**Re: Revised Site Assessment Summary & Proposed Variance and Remediation Workplan Addendum  
SRO 5 State Com #506H & 507H  
NMOCD Incident No. nRM1933644528  
Unit I/L, Section 32/33, Township 25S, Range 28E  
Latitude 32.08505, Longitude -104.10065  
Eddy County, New Mexico**

On behalf of ConocoPhillips (COP), TRC Environmental Corporation (TRC) is providing this Revised Site Assessment Summary & Proposed Variance and Remediation Workplan Addendum (Addendum) for COP's SRO 5 State #506H & 507H (Site). The *Revised Site Assessment Summary & Proposed Variance and Remediation Workplan* for the Site was submitted to the New Mexico Oil Conservation Division (NMOCD) in early December 2021. The document proposed the following remedial actions to address soil with chloride concentrations above NMOCD Closure Criteria:

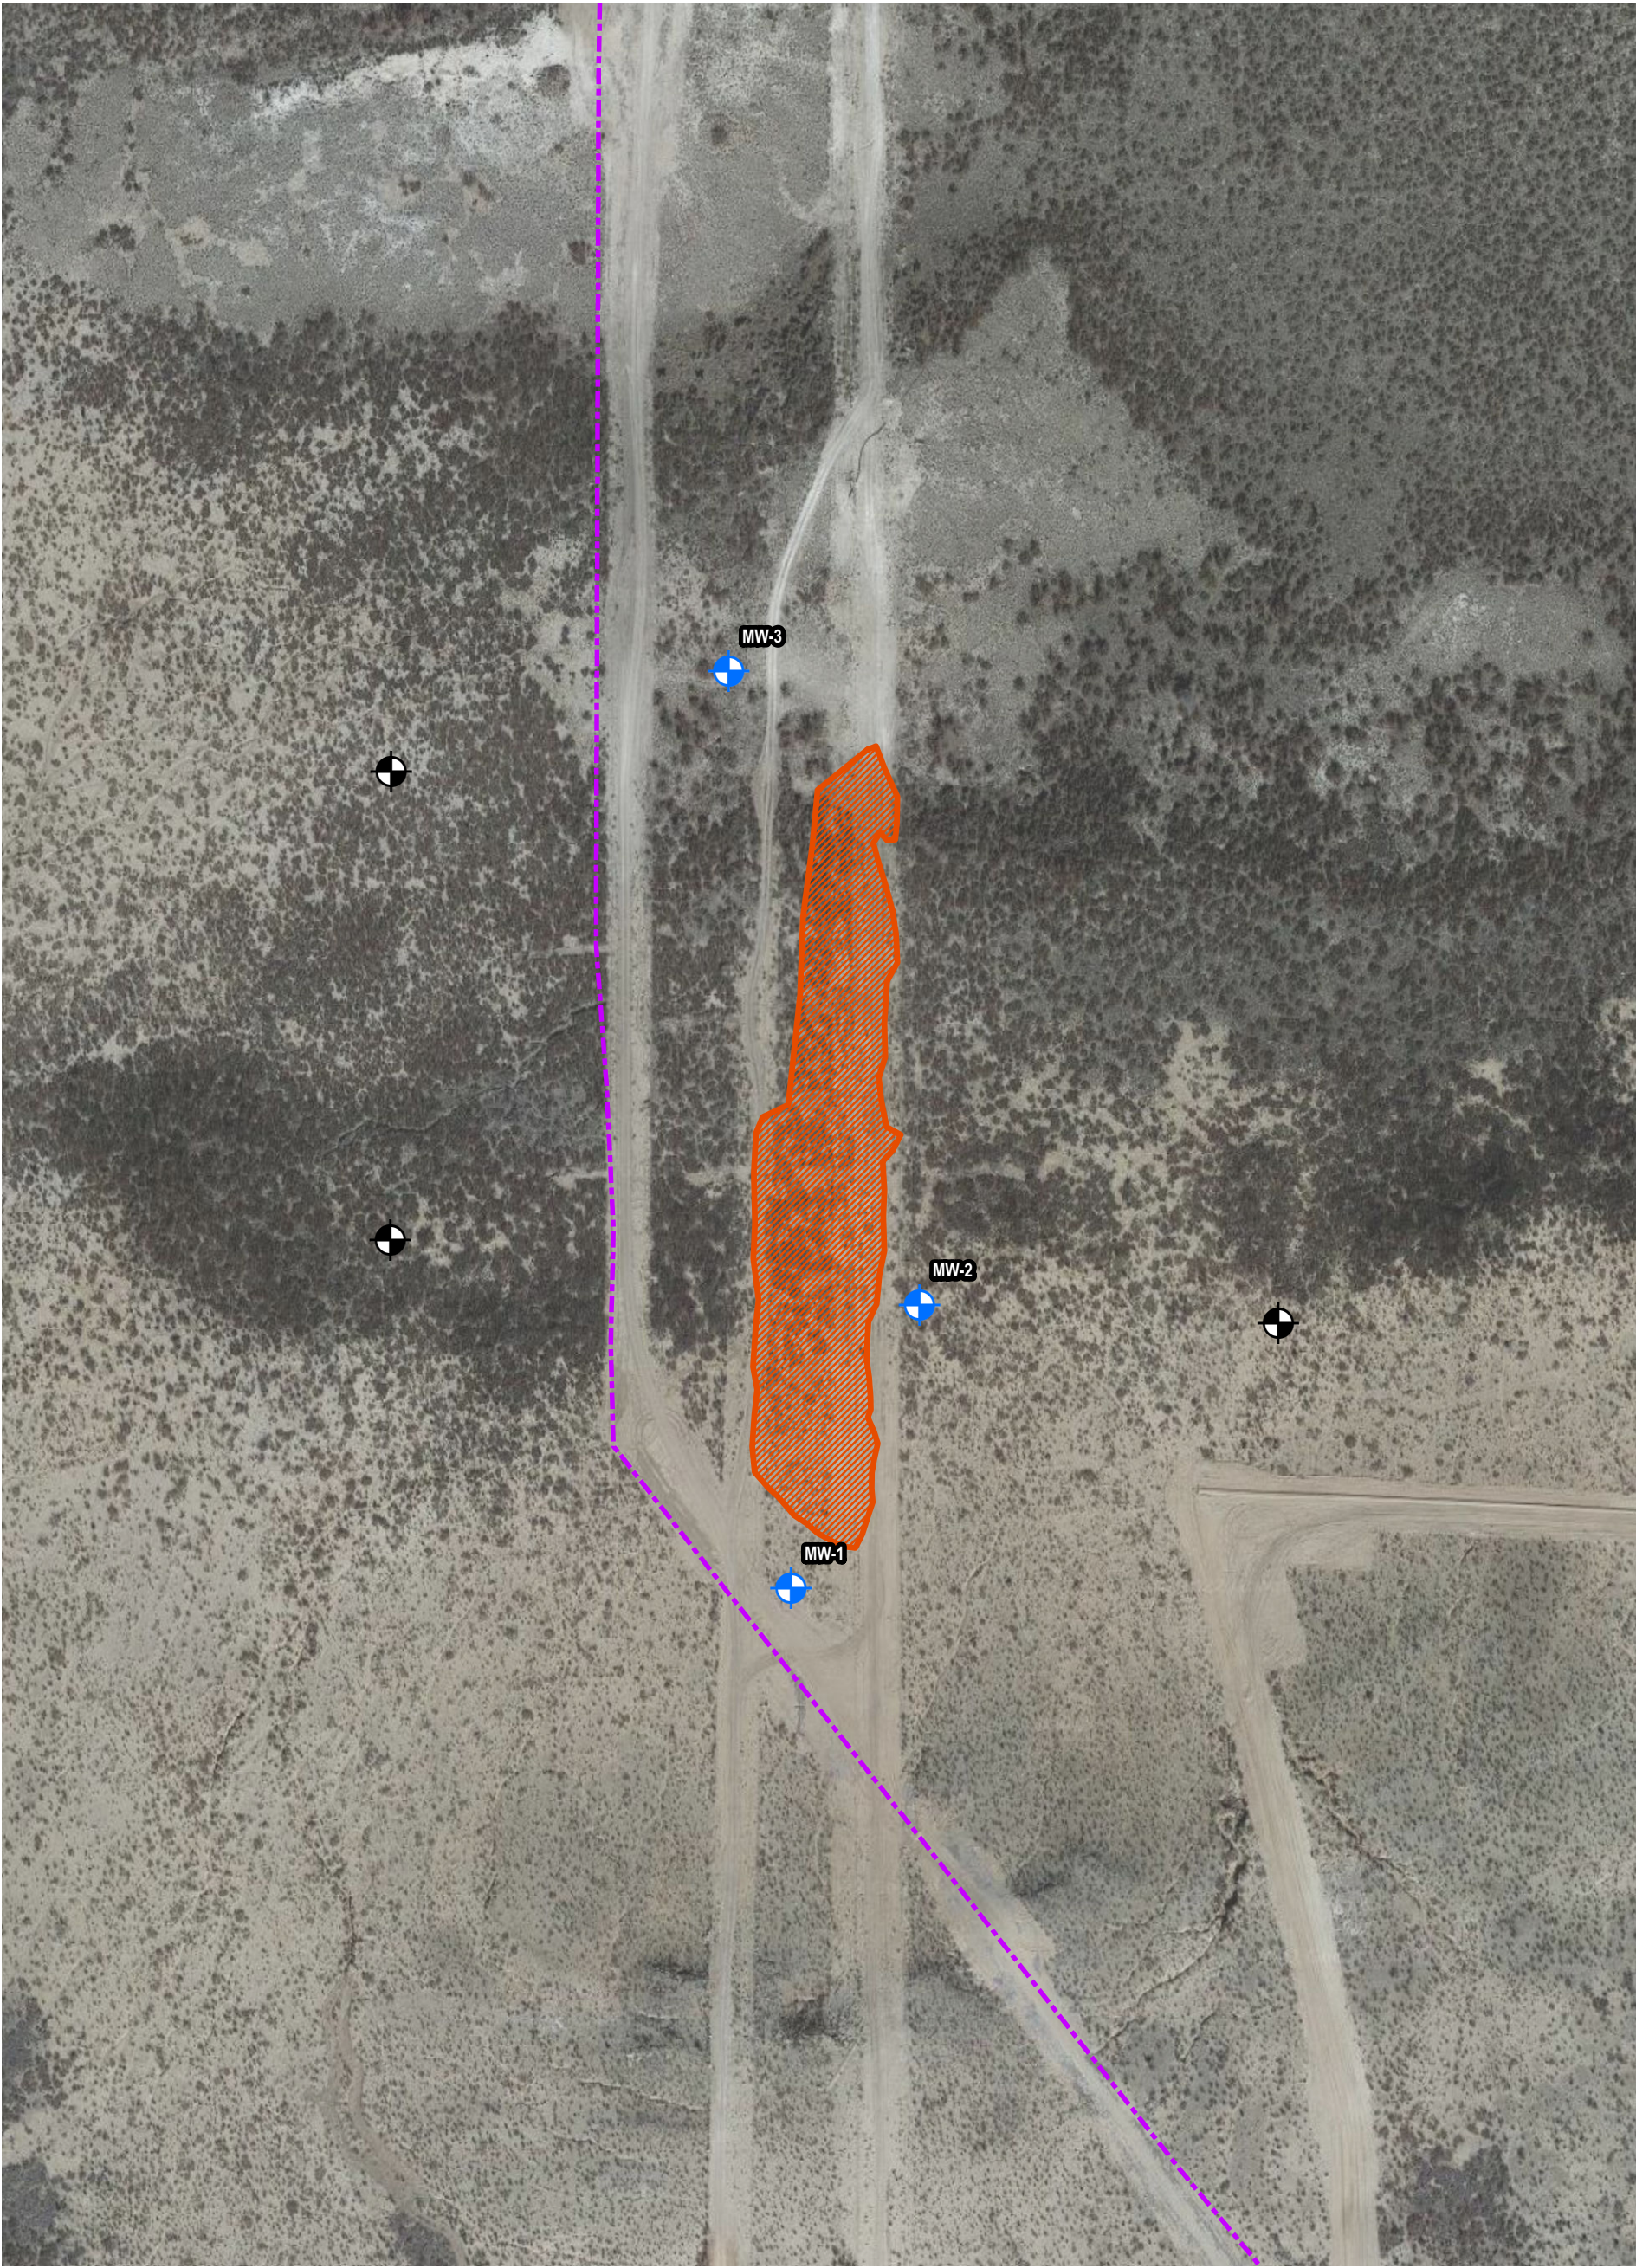
- Three (3) additional monitor wells will be installed. The proposed easternmost well will be laterally moved northward to be in-line with MW-2; however, the well will not be located so far north that it is installed into the presumed alluvium or Rustler/alluvium transition.

The NMOCD provided denial of the December 2021 *Revised Site Assessment Summary & Proposed Variance and Remediation Workplan* on May 12, 2022, via the E-permitting portal. The NMOCD's denial e-mail indicated adherence to the most stringent closure criteria for the entirety of the Release Site, a sample frequency variance of one (1) confirmation soil sample per 500 square feet of floor and sidewall footprint, and overburden sample frequency of one (1) soil sample per 200 cubic feet. The monitoring wells were approved, but the easternmost water well was requested to be moved northward by approximately 150 feet.

- Three (3) additional monitor wells will be installed. The proposed easternmost well will be laterally moved northward to be in-line with MW-2, but not so far north that the well is installed into the presumed alluvium or Rustler/alluvium transition.
